**Comments on Public Registry File: 5991.00 - Canadian Premium Sand Inc.
Environmental Act Proposal - Wanipigow Sand Extraction Project
Submitted by Don Sullivan on behalf of What The Frack Manitoba Inc.**

Comments on Public Registry File: 5991.00 - Canadian Premium Sand Inc. - Wanipigow Sand Extraction Project

Figure 1 Project layout showing water bodies that may be affected by the Project including two unnamed creeks draining the southern Project area. **Figure 1** is reproduced from the AECOM EAP (Figure: 1-1).

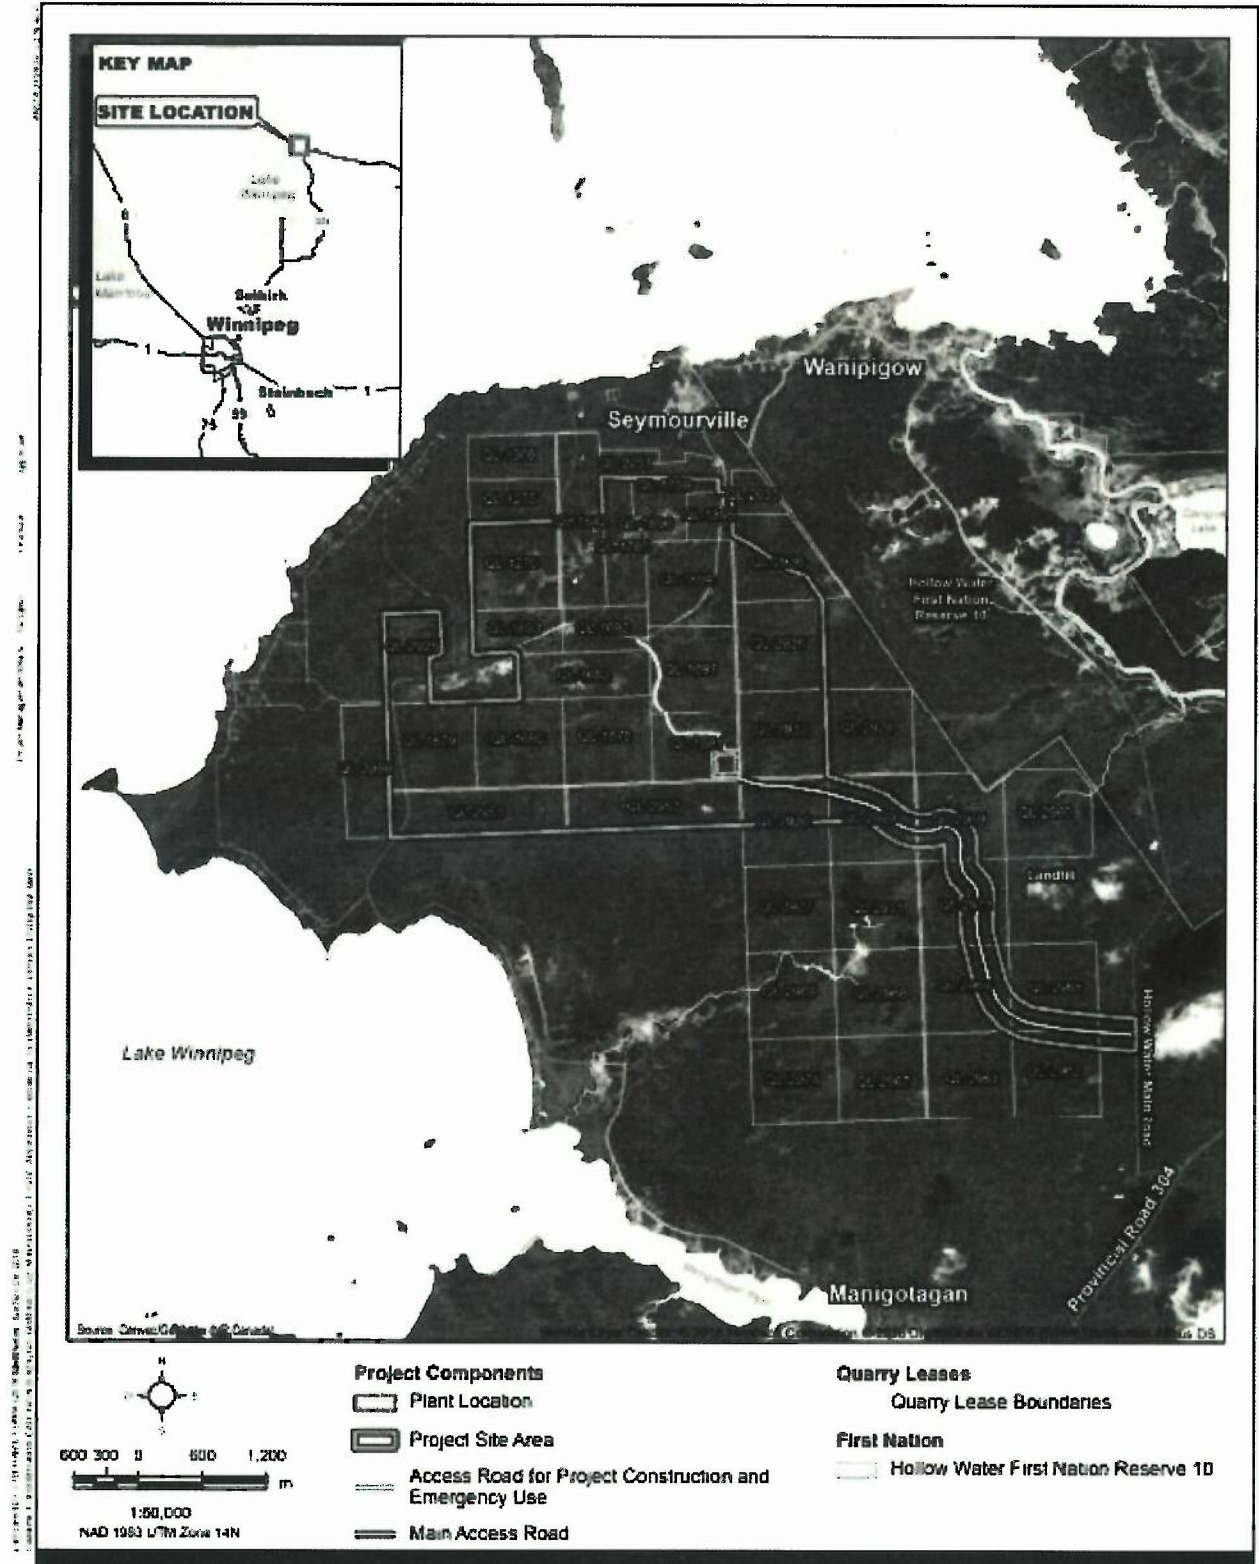
The fish and fish habitat that may be affected by the Project include sections of the Wanipigow River, Manigotagan River mouth, Lake Winnipeg and two unnamed Creeks shown in **Figure 1**.

The unnamed creeks have not apparently been evaluated for fish, and fish habitat. Such an evaluation should be made as part of this Project as the water flow and fish habitat in these creeks may be adversely by drainage from the Project. Portions of the unnamed creeks are within the quarry lease boundaries of the Project as shown in **Figure 1**. Should there be fish habitat within these creeks, the claim in the AECOM EAP that there is no fish habitat within the Project site would be inaccurate.

Figure 3 Process flow sheet for wet plant from Appendix A of AECOM EAP showing three sand stockpiles each 70 meters in height with two having a 140 meter base and the third a 325 meter base

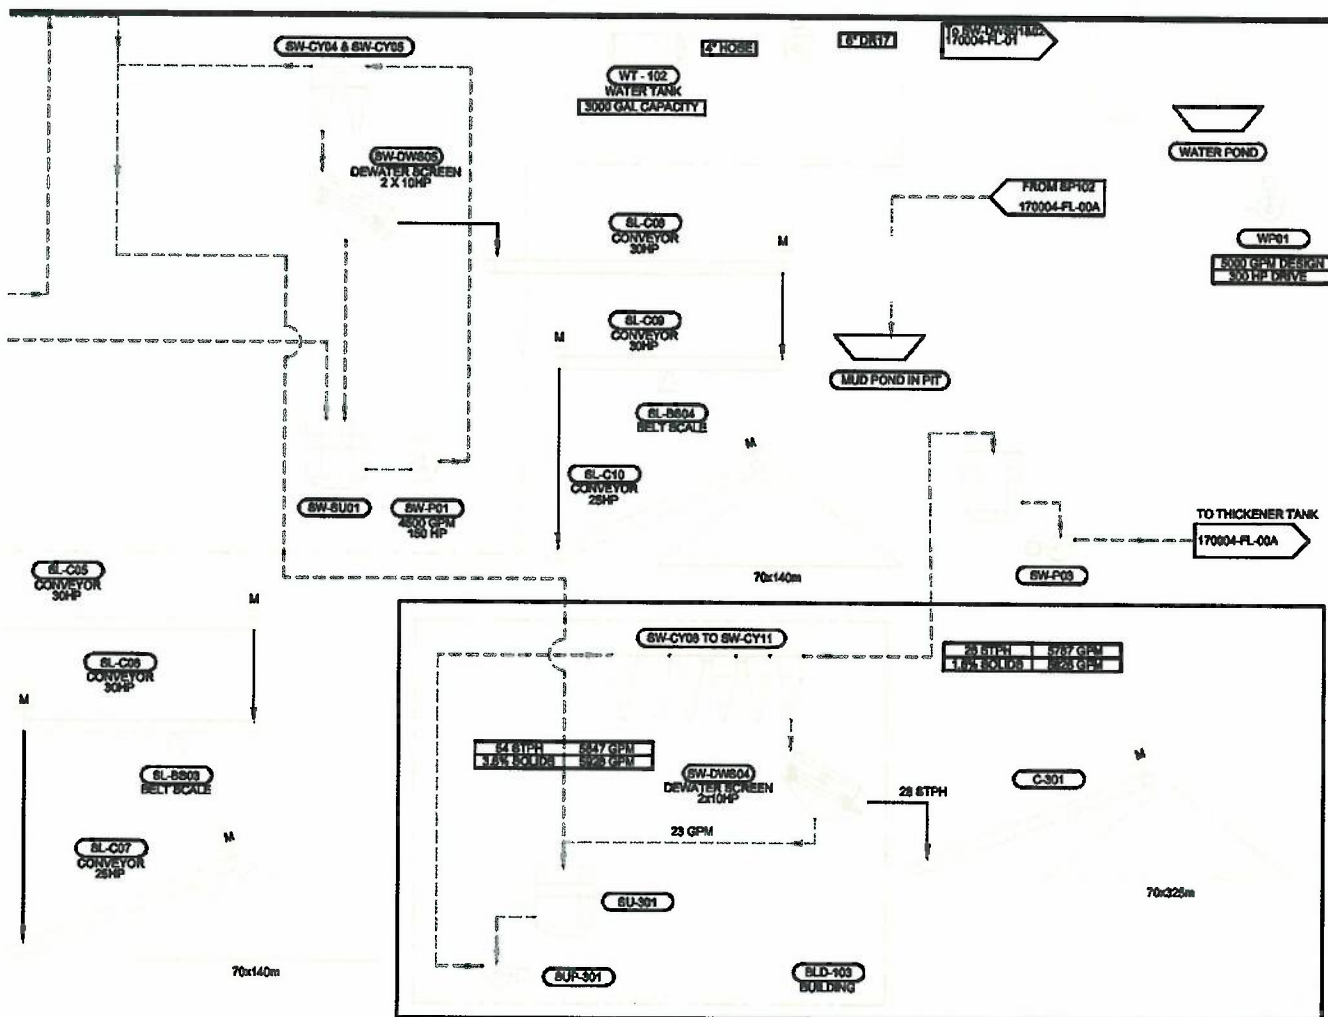
In Wanipigow the sand deposit is below the water table and will not be quarried in winter. A propane heated winter storage plant to hold 250 000 tonnes of wet sand destined for the wash plant from the quarry is described in the CPS Technical Report. No mention of a large heated winter wet sand storage plant is made in the AECOM EAP. However, three large 70 meter high outdoor sand stockpiles are shown in the process flow sheet for the wet plant in appendix A of the AECOM EAP reproduced in **Figure 3**.

Consistent with the practice in Minnesota and Wisconsin to operate the wash plant during the warm months only (<https://superior-ind.com/testimonials/soaring-silica-sand/>), Appendix X of the CPS Technical report states that the wash plant will operate 180 days a year at 80% capacity. The wash plant will likely be drained in the winter to prevent freezing damage to equipment. Winter heating of the wash plant is possible but

costly. The water in the sand slurry in the scrubber, hydrosizers and storage tanks would likely evaporate. The dried sand could solidify and render re-hydration next to impossible unless the sand is kept wet all winter. Corrosion of the tanks would like occur as the water inside would be static and may contain acid from the pyritic acid drainage collected in the active quarry cell sump pit. It would seem that drainage of the wash plant will be necessary.

There is no mention in the AECOM EAP of the disposition of the drained wash plant water or the amount of water required for recharging of the wash plant every spring. Not enough information is supplied in the AECOM EAP to determine the volume of water that would have to be drained from the wet operation to prevent freezing in winter. This water will be to some extent will contain toxic flocculants, acid (from collected pyritic acid drainage) and sediment all of which would be harmful to fish habitat should run off or spring melt water carry the drained water to the creeks, rivers or lake. Since the wash water from the plant is recycled, toxic flocculants and acid will be expected to accumulate and concentrate as time goes on increasing the risk to fish habitat. Evaporation of process water from the settling pond and numerous tanks, hydrosizers and cyclones will further concentrate acid and toxins.

A third major source of silica dust excluded from the modelling is wind blow dust from three 70 meter high sand stockpiles on site as shown in **Figure 3** which is an excerpt from the process flow sheet of the wet plant given in appendix A of the AECOM EAP (<http://www.mfe.govt.nz/sites/default/files/media/Air/good-practice-guide-dust-2016.pdf>).

It should also be mentioned that the safe angle of repose has not been considered for the stockpiles. The two stockpiles having a base of 140 meters would have a slope angle of 45° which is above the angle of repose for dry sand of 34° (https://en.wikipedia.org/wiki/Angle_of_repose). Sand slide may endanger workers (https://www.hsa.ie/eng/Your_Industry/Quarrying/Stockpiles_Tips_and_Lagoons/Management_of_Tips_and_Stockpiles/). This is another example of the lack of due diligence and planning by the proponent pertaining to worker safety and human health.

Figure 4 Plant layout showing dams (blue lines) to hold settling pond

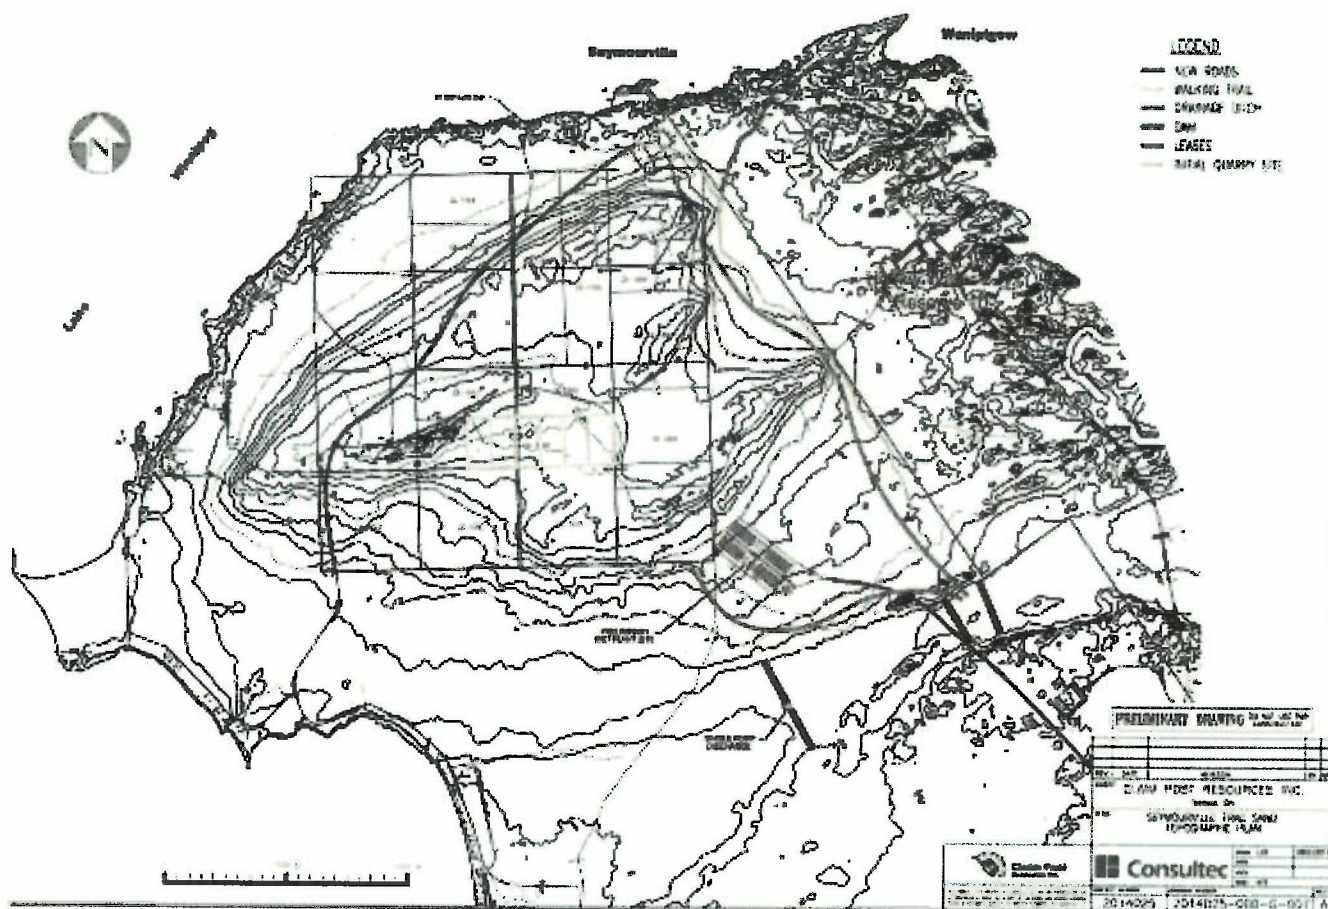
The ponds, confined by three dams, are in a swampy area south of the plant buildings. This swampy area is drained by one creek flowing west into the mouth of the Manigotagan River and another creek flowing east to the Wanipigow River as shown in **Figure 1**. The design shown in **Figure 4** may be outdated, however, the swampy area appears to be the only feasible location for the settling pond as other available plant areas are either quarry site or steep down slopes as indicated by the contour lines in **Figure 4**.

The west most dam has a single point discharge presumably for overflow in case of heavy rains or spring melt water. Such discharge would carry plant process water containing sediment and flocculants that would be harmful to fish habitat in the unnamed creeks, Manigotagan mouth, Wanipigow River and in Lake Winnipeg.

Figure 4 shows that acid drainage from the pyrite in the overburden, sand rejects and pyritic oolite in the pit bottom or winter drainage process water would likely flow down slope towards the two creeks and two rivers or to Lake Winnipeg.

Clearly there is a potential for release of process water from pond spillage and leakage and possible drainage from winter wash plant shut down. Drainage of the released process water to nearby water bodies may affect fish and fish habitat.

Figure 7 Dust Collection from two Bag Houses and all Dry Plant Building

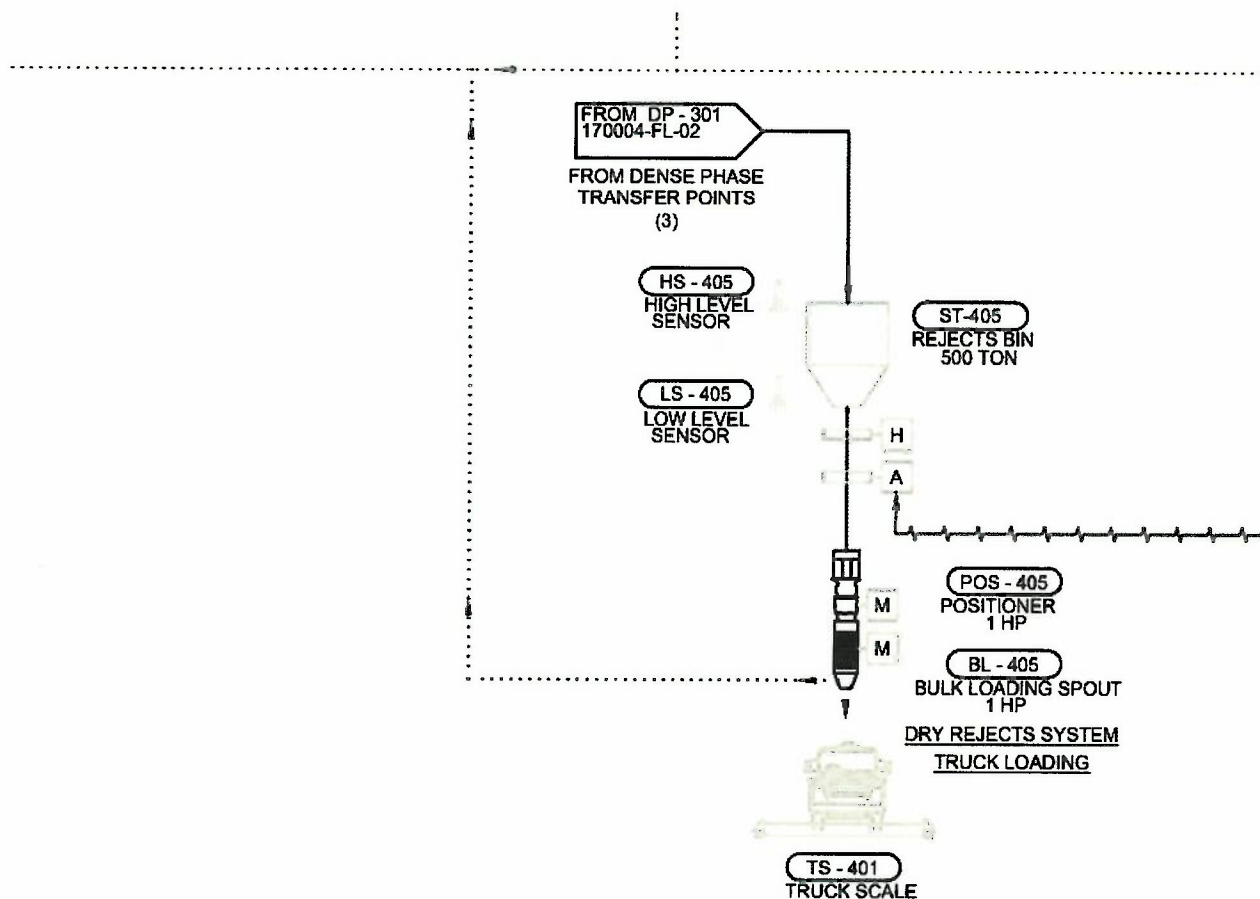
The onsite disposal of dust from the two bag houses and from the dry plant dust collection system routed to a 500 ton rejects bin is not included in the model source. The rejects bin is shown in Figure 7 taken from an excerpt from the process flow sheet of the storage and loading area of appendix A of the AECOM EAP. Output from the 500 ton rejects bin is shown to be split with some loaded on a truck and some routed off page. The off page route is likely onsite disposal as is the practice in silica mines in Wisconsin (<https://dnr.wi.gov/topic/Mines/documents/SilicaSandMiningFinal.pdf>). Onsite disposal of dust in the 500 ton reject bin may create large amounts of airborne respirable PM2.5 and PM10 that would be a hazard to workers and surrounding communities. The destination of trucks loaded with respirable silica dust is not described. Unloading of the trucks may involve a risk of exposure to silica dust.
